# PARTS & SERVICE NEWS

REF NO.	AA99057
DATE	February 22, 1999

**SUBJECT:** TRANSMISSION BREATHER UPGRADE

**PURPOSE:** To announce a replacement transmission breather

Figure 1 Transmission Breather

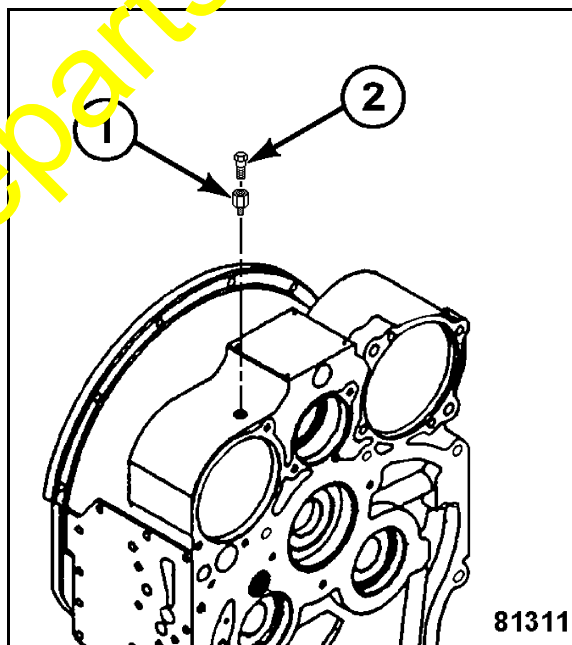
An adaptor and new breather are available to eliminate slobbering oil at the transmission breather.

Item	Part Number	Description
1	1434906-11	Adaptor
2	1434995-11	Breather
